Access Compliance Report

Public Rights-of-Way

(Curb Ramps)

Intersection ID: 48634	Main Street: GRANDE_HEIGHTS_DR	Cross Street: DOMINION_CREST_DR	Location: NE
ADA ID: 1D99BD66E533	Ramp Type: Perp	Initial Pass/Fail: Pass	Overall Compliance: No
Codes/Mitigation Info/Possible Solution		Field Measurements/Component Compliance	
Severity Score: 2.5

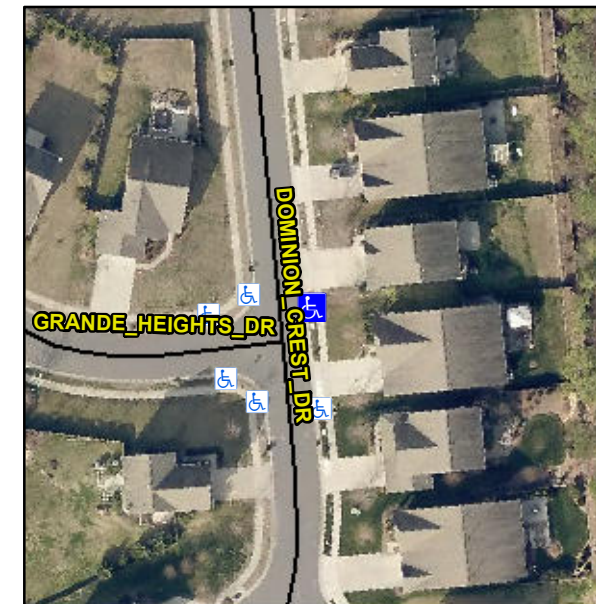
Not Found, R304.2.2, R304.2.2-Perp, R304.3.2-Para

Compliance	Description	Data	Compliance	Description	Data
N/A	Ramp Length (in)	47.0	No	Ramp Slope (%)	8.4
Yes	Ramp Width (in)	48.0	Yes	Ramp XSlope (%)	2.0
N/A	Flare Type LT	Sloped	N/A	Flare Type RT	N/A
N/A	Flare Slope LT (%)	8.2	Yes	Flare Slope RT (%)	1.5
N/A	Flare Traversable LT?	Yes	N/A	Flare Traversable RT?	Yes
Yes	Landing Length (in)	48.0	Yes	DWS Provided?	Yes
Yes	Landing Width (in)	48.0	Yes	DWS Contrast?	Yes
No	Landing Slope (%)	2.8	Yes	DWS Length (in)	24.5
Yes	Landing X Slope (%)	2.8	Yes	DWS Full Width?	Yes
N/A	Landing Curb? (Y/N)	No	Yes	DWS Offset (in)	0.0
N/A	Shared Landing?	No			
Yes	Gutter Ponding?	No	Yes	Gutter Slope (%)	3.0
Yes	Gutter Lip Ht (in)	0.0	Yes	Gutter X Slope (%)	3.2
N/A	Painted X Walk1?	No	N/A	Painted X Walk2?	N/A
	X Walk 1 Direction	To W		X Walk 2 Direction	N/A
N/A	X Walk 1 Width (in)	N/A	N/A	X Walk 2 Width (in)	N/A
	X Walk 1 Slope (%)	2.6		X Walk 2 Slope (%)	N/A
	X Walk 1 X Slope (%)	3.9		X Walk 2 X Slope (%)	N/A

Remove & Replace Entire Ramp.
